Agenda Item # 5 SUB-003022-2024

Resubdivision of Lot 19, Resurvey of Third Addition to Dog River Park Subdivision

- Subdivision approval to create two (2) legal lots of record from one (1) legal lot of record.

DETAIL SITE PLAN

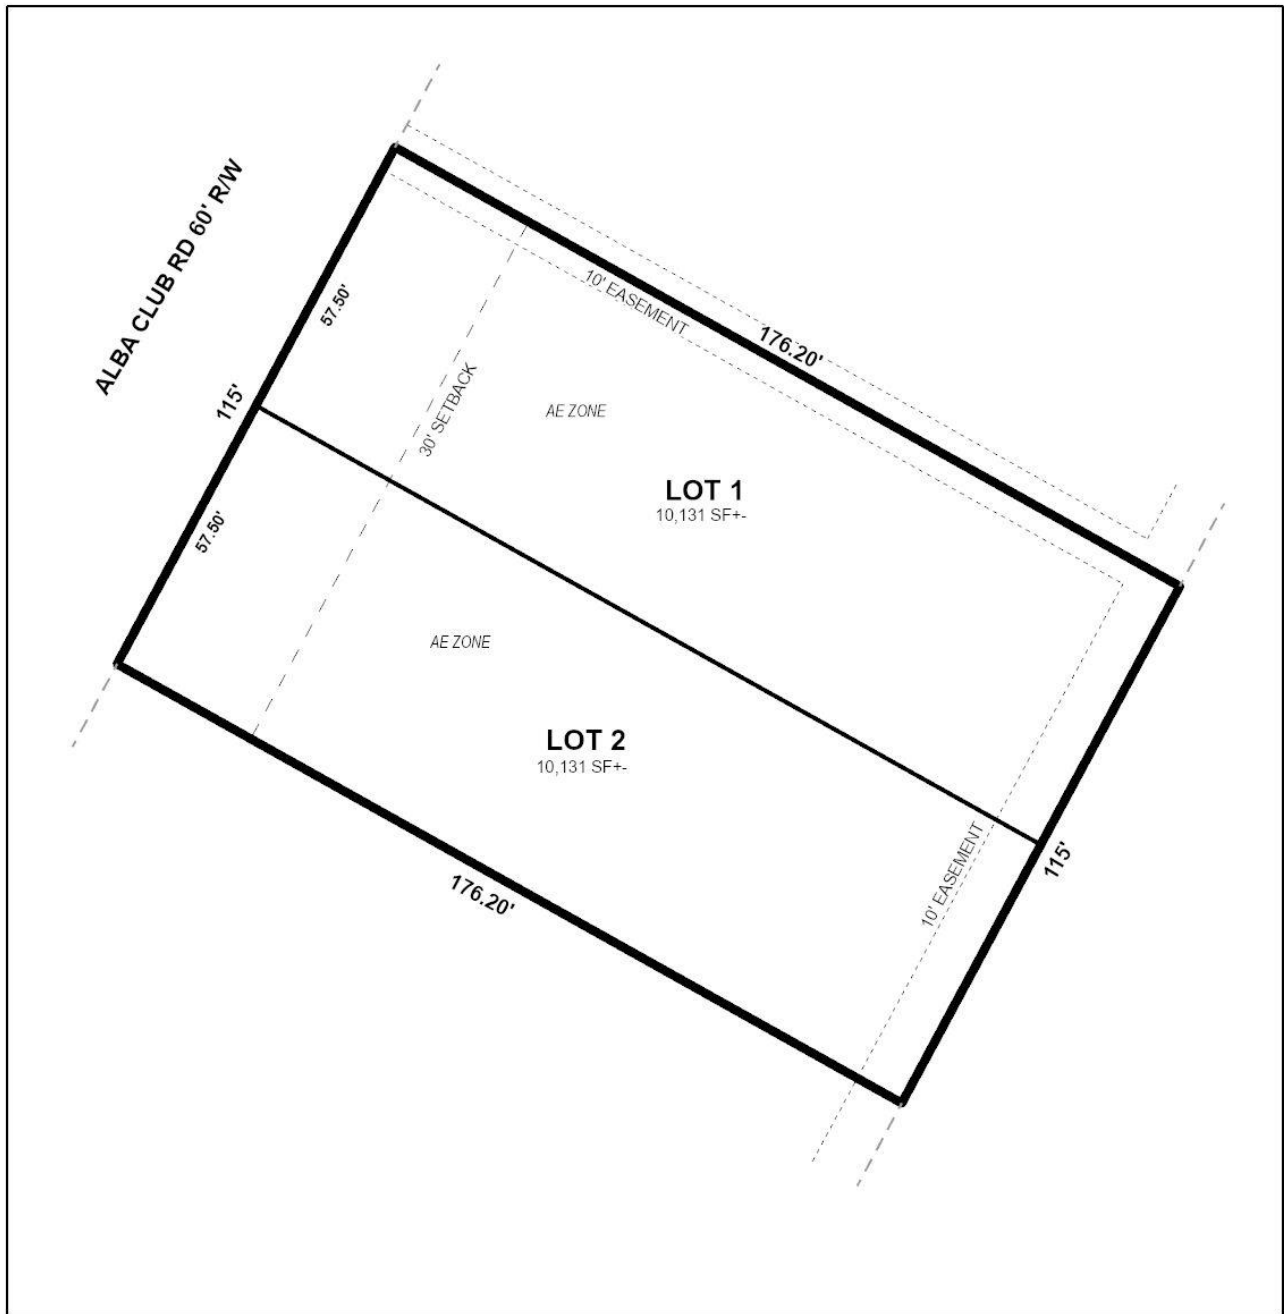
The site has frontage on Alba Club Road, a minor street without curb and gutter requiring a 60-foot right-of-way width. The preliminary plat depicts a sufficient right-of-way width at this location, making additional dedication unnecessary. This information should be retained on the Final Plat, if approved.

Each lot, as proposed, is 57.50 feet in width, which is not compatible with the minimum 60-foot width requirement of Section 6.C.2(b)(2) for residential lots located within the suburban sub-district. While not in character with the surrounding neighborhood, the reduced lot widths are not anticipated to have a negative impact considering they are wide enough to support development that is compliant with the applicable standards of the Unified Development Code (UDC). As such, a waiver of Section 6.C.2(b)(2) may be appropriate.

The lots, as proposed, exceed the minimum size requirements for lots served by public water and sanitary sewer in an R-1 Suburban district and are appropriately labeled in square feet and acres on the preliminary plat. If approved, this information should be retained on the Final Plat; or placement of a table on the Final Plat with the same information will suffice.

A 30-foot front yard setback is illustrated along Alba Club Road which is consistent with the previously recorded subdivision plat; however, only a 25-foot setback is required on lots zoned R-1 in the Suburban sub-district, per Article 2, Section 64-2-5.E. of the UDC. As such, retention of at least a 25-foot front yard setback on the Final Plat should be required, if approved.

1. Retention of the right-of-way along Alba Club Road, as depicted on the preliminary plat;
2. Retention of the lot sizes in square feet and acres on the Final Plat, or provision of a table on the Final Plat with the same information;
3. Retention of at least a 25-foot front yard setback along Alba Club Road;
4. Compliance with all Engineering comments noted in this staff report;
5. Placement of a note on the Final Plat stating the Traffic Engineering comments noted in this staff report;
6. Compliance with all Urban Forestry comments noted in this staff report; and
7. Compliance with all Fire Department comments noted in this staff report.
